# 45 McLaren St

## North Sydney

Response to Council RFI

February 2024

## Dual core study

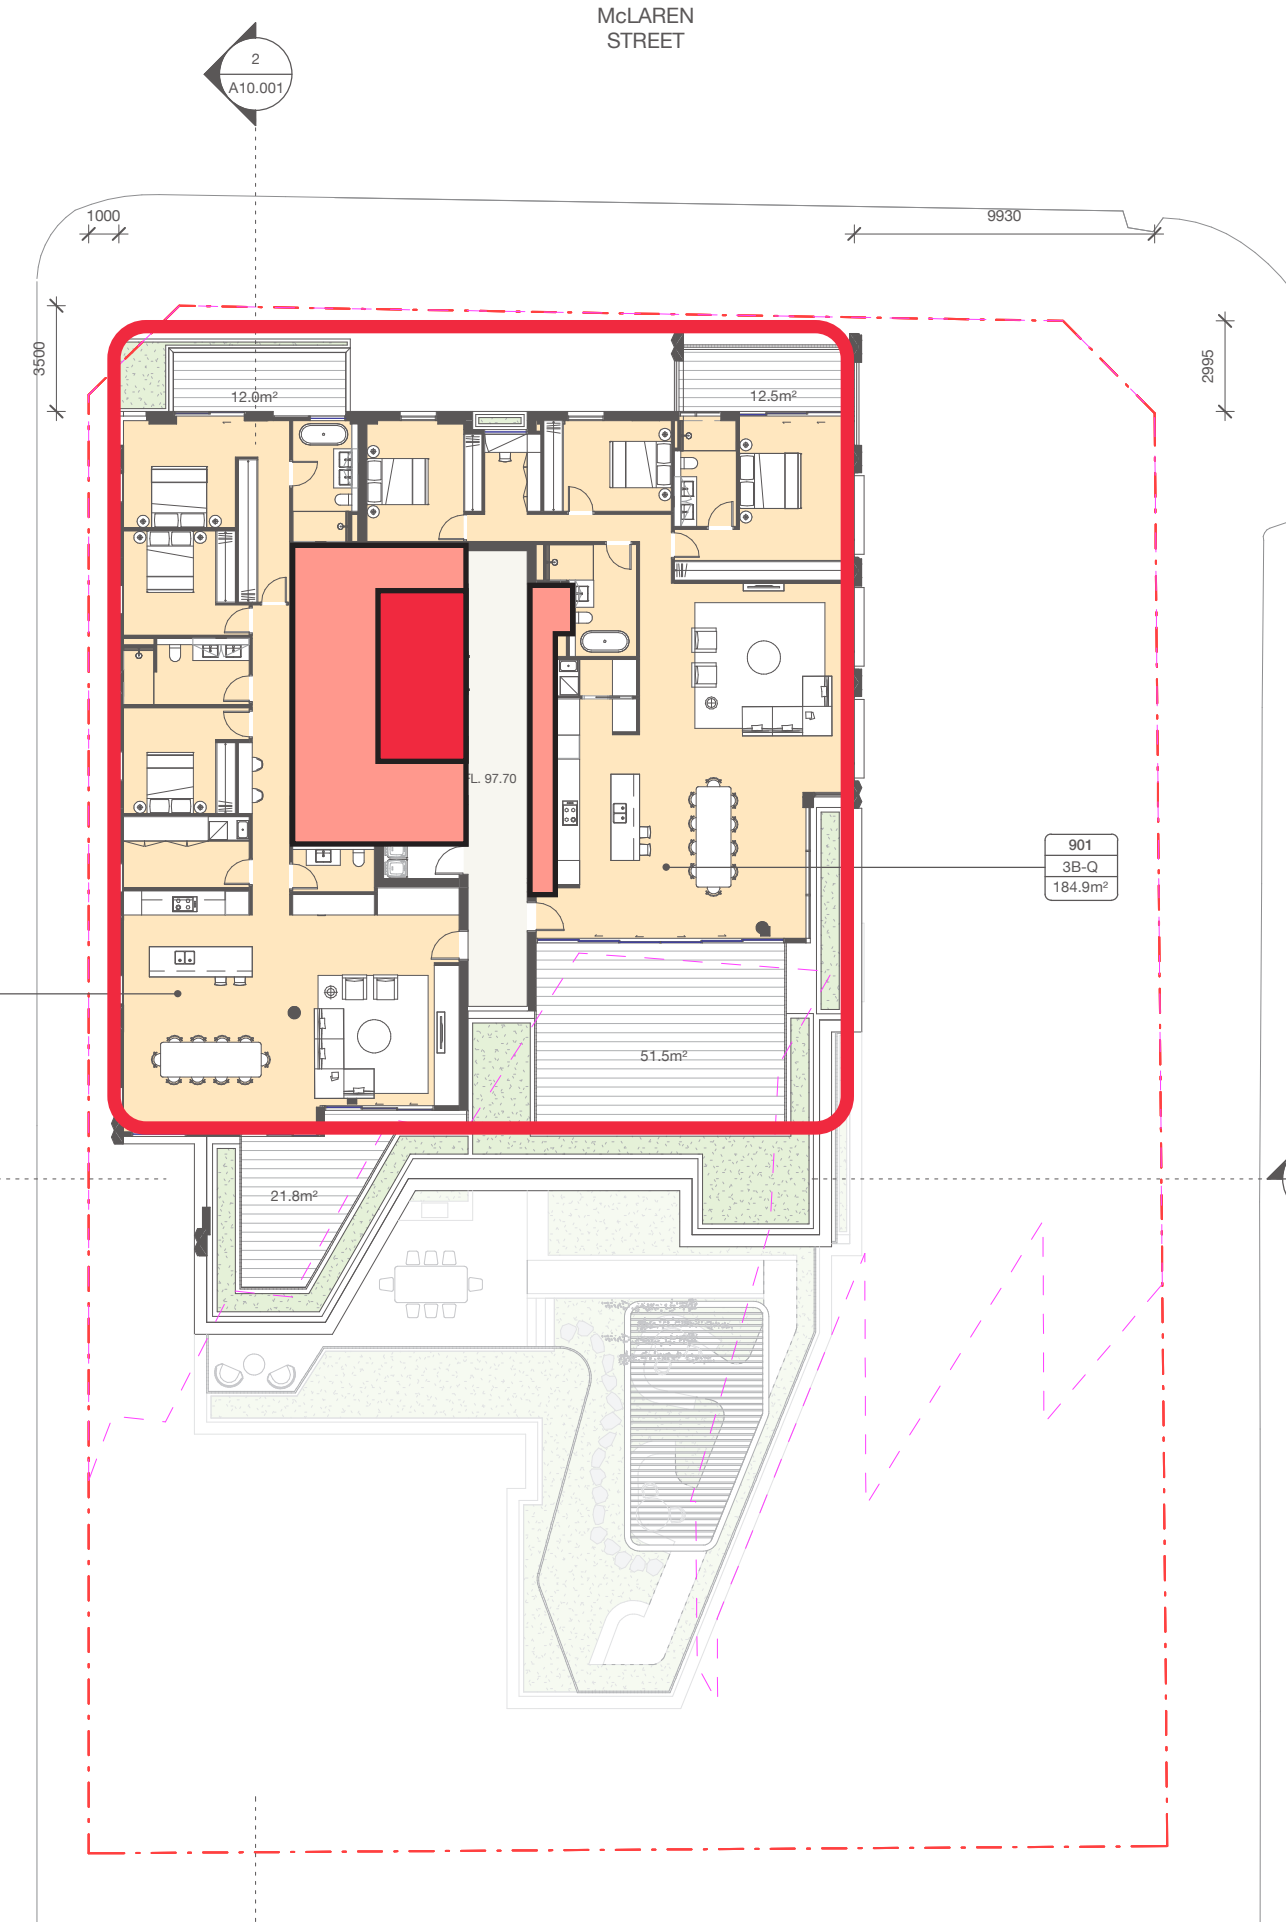
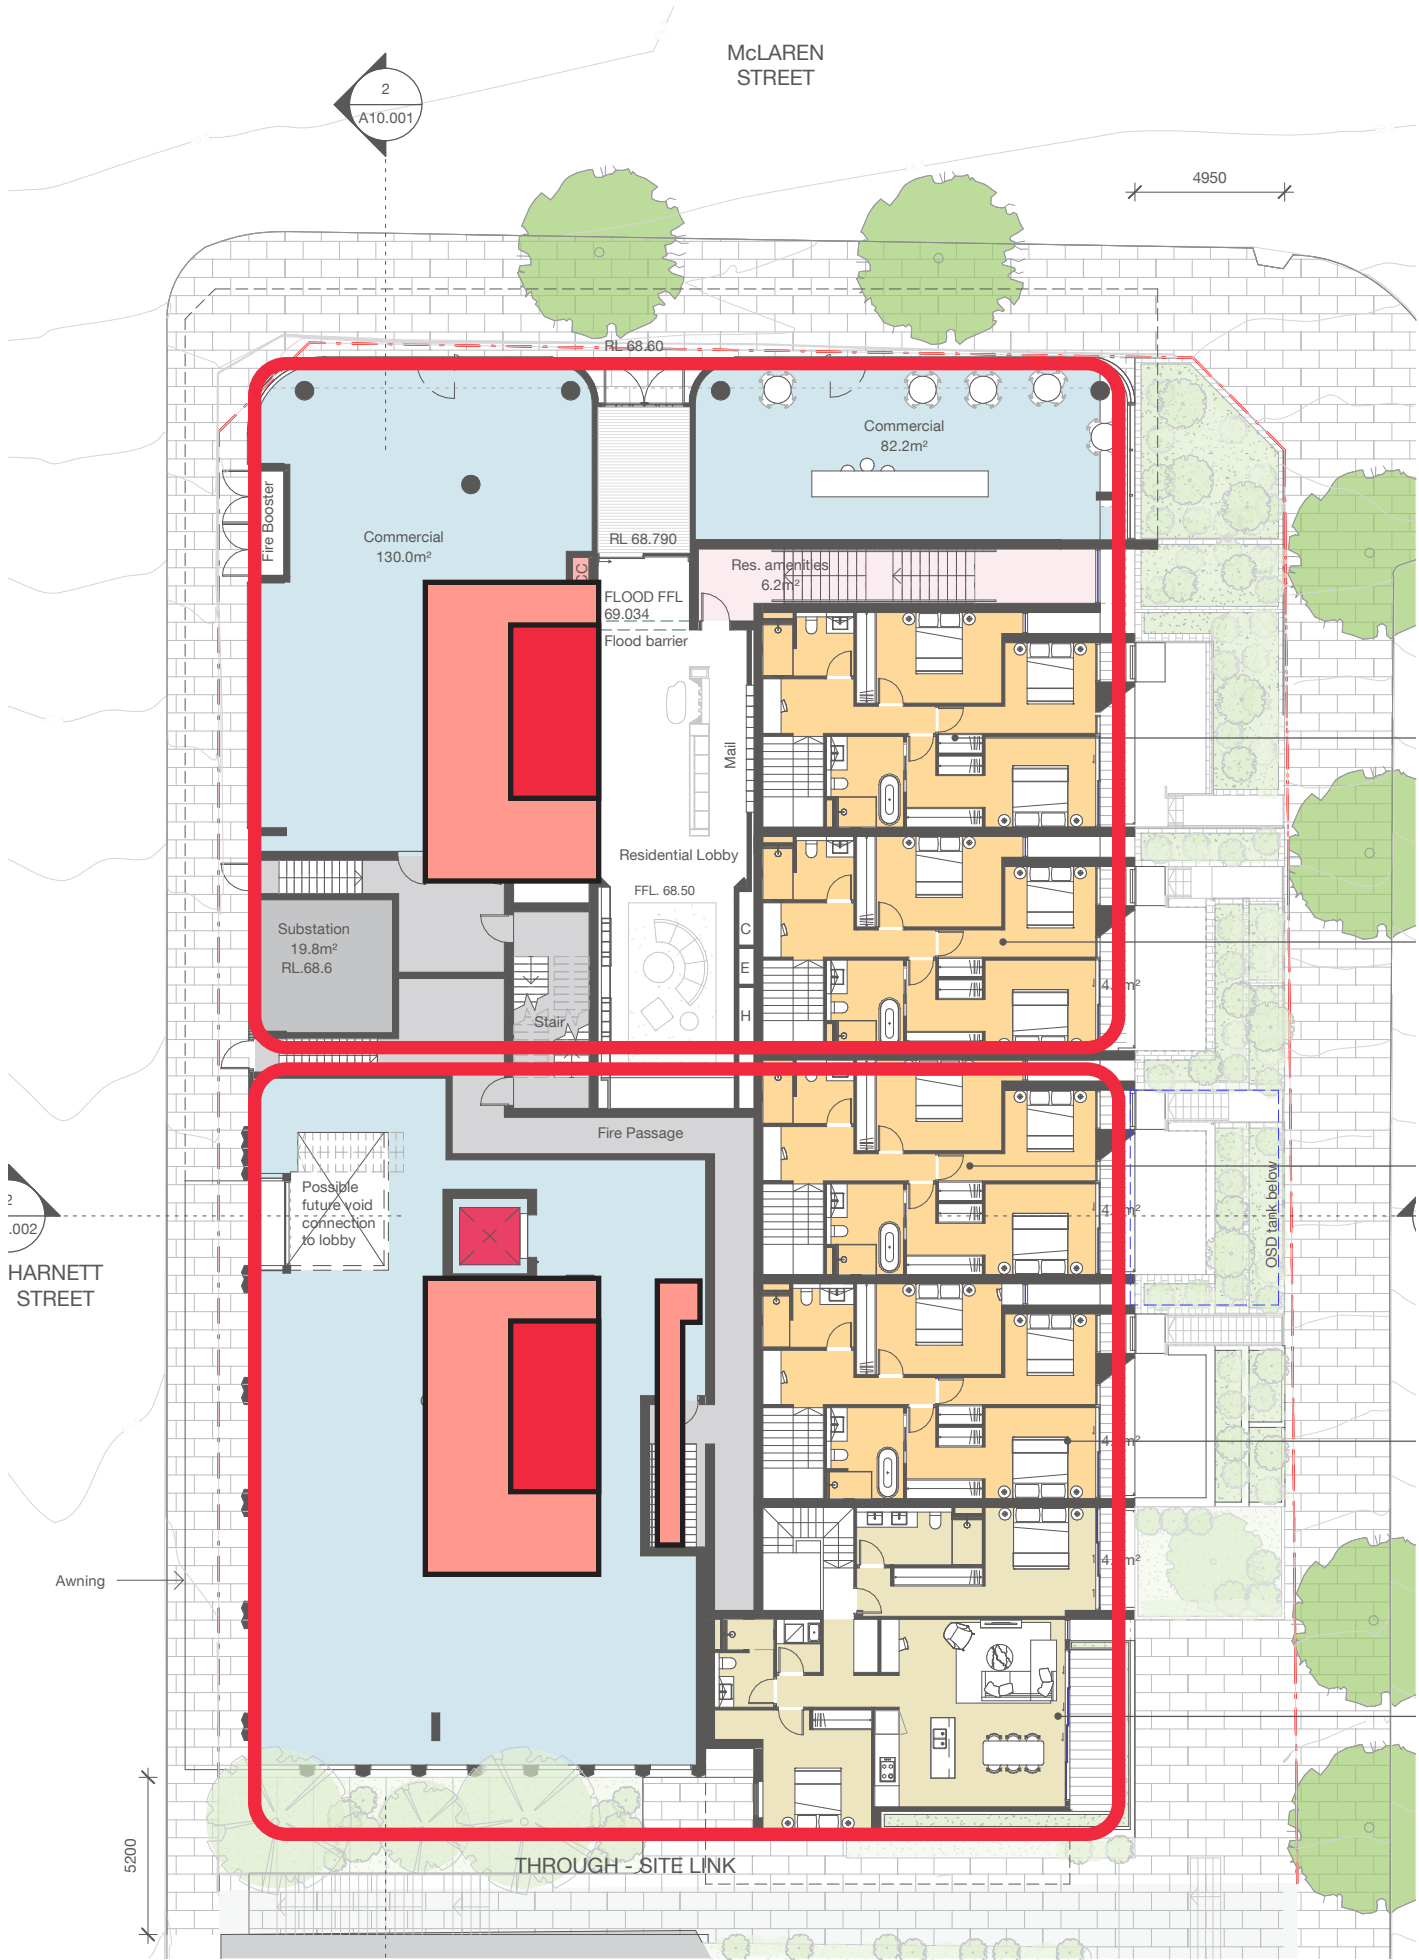
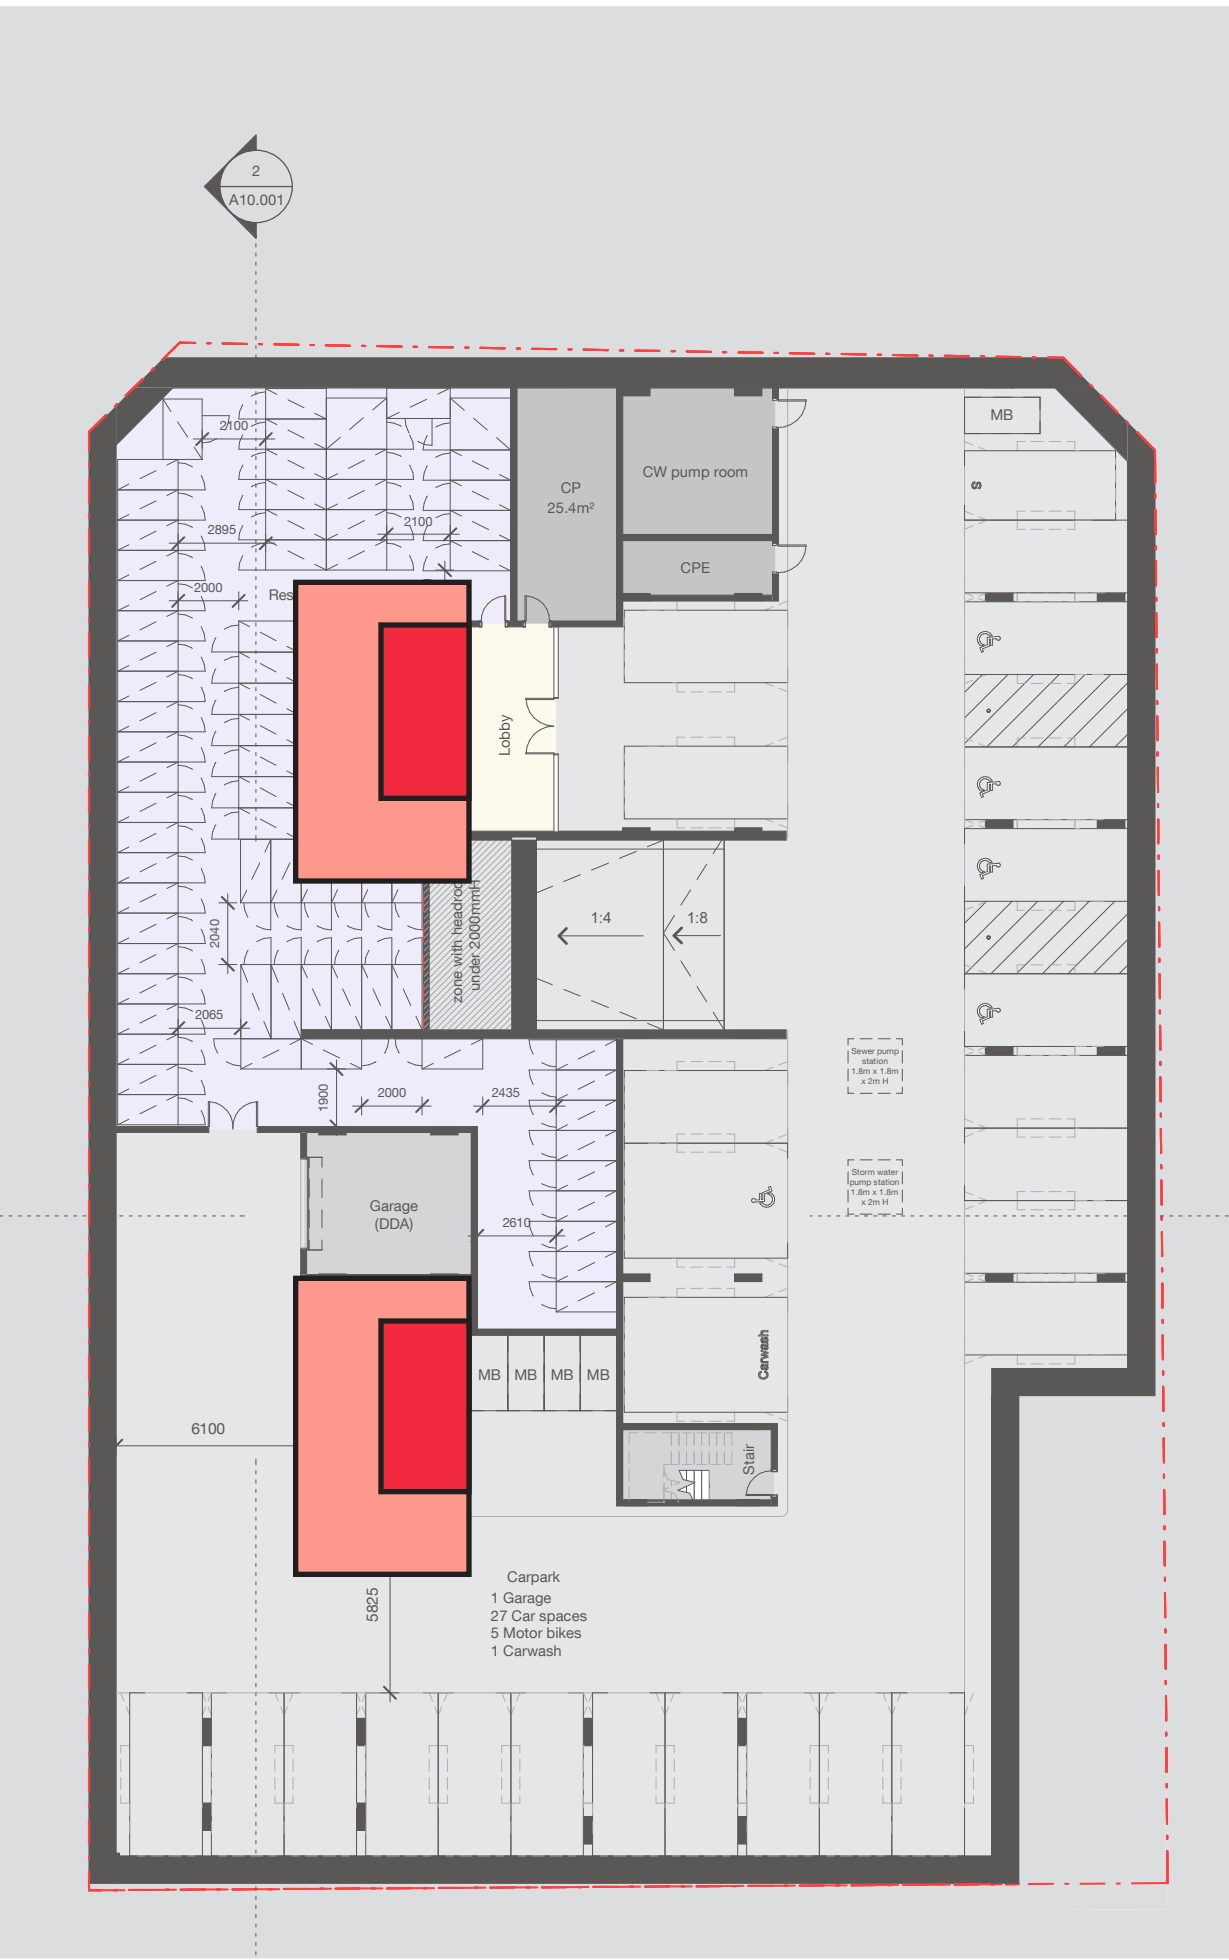
*Common circulation - The 35m long **internal corridor serving up to 10 apartments** per floor is unacceptable. The ADG limits this to eight dwellings. **A second core** and / or an open stair **should be considered** up to level 6, which could also allow enhanced daylight penetration to the corridor.*

If additional core is be introduced, the most logical location for second core is located further south, dividing the floor plate into two - serving lower floors only.

- Duplication of lifts, stairs and services
- Need to additional plant areas (ie. stair press etc.)
- Less efficient building
- Increased embodied carbon due to additional structure
- Likely to reduce number of units & carspaces
- Negatively impacts viability of commercial tenancies on podium levels.
- Likely to increase cross ventilation.
